Site Plan: Alternate Transmission Addendum

Prepared for: Crook Flat Solar Farm LLC		TITLE: ALTERNATE TRANSMISSION ROUTES
REV: MA	DRAWN BY: Mark Pasterman	PAGE: 11 of 11

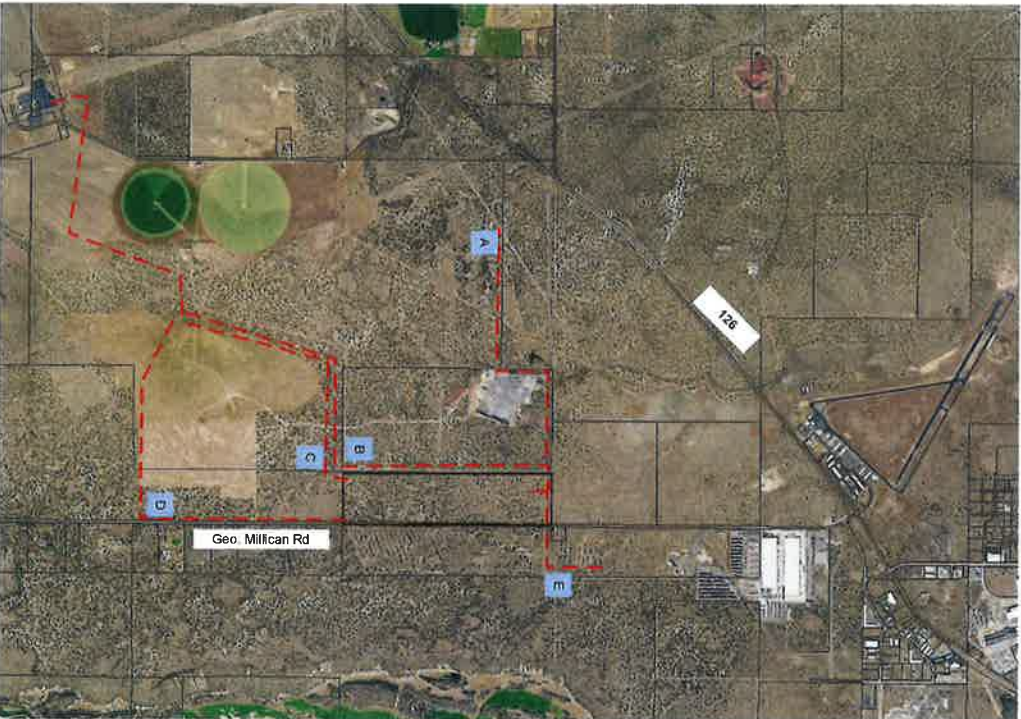
- A. ATL path across TL 1231 to a connection point on TL 1208 and the Pacificcorps Baldwin-Ponderosa Transmission line.
- B. ATL Path on TL 1231, 1208 alongside or underneath Pacificcorps Houston Lake -Ponderosa Transmission Line and connecting to either Ponderosa or Corral Substation.
- C. ATL Path on TL 1229 and 1208 to BPA Ponderosa Station.
- D. ATL Path on TL 1229 and 1208 adjacent to CEC distribution line, then to Ponderosa Substation.
- E. ATL Path across Millican Road either under or adjacent to existing PAC 115kV line on TL 2200 to Sterns Butte Substation (Q0850) location.
